REVISION TO STANDARD DRAWINGS

802-SNWW-07 Sign Walkway Details

### SIGN WALKWAY DETAILS

STANDARD DRAWING NO. 802-SNWW-07

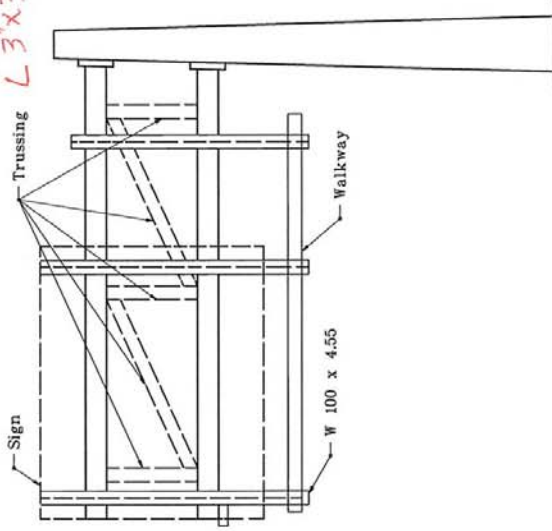
- ① See Standard Drawing 802-SNWW-08 for Detail A.
- ② See Standard Drawing 802-SNWW-08 for Detail B.
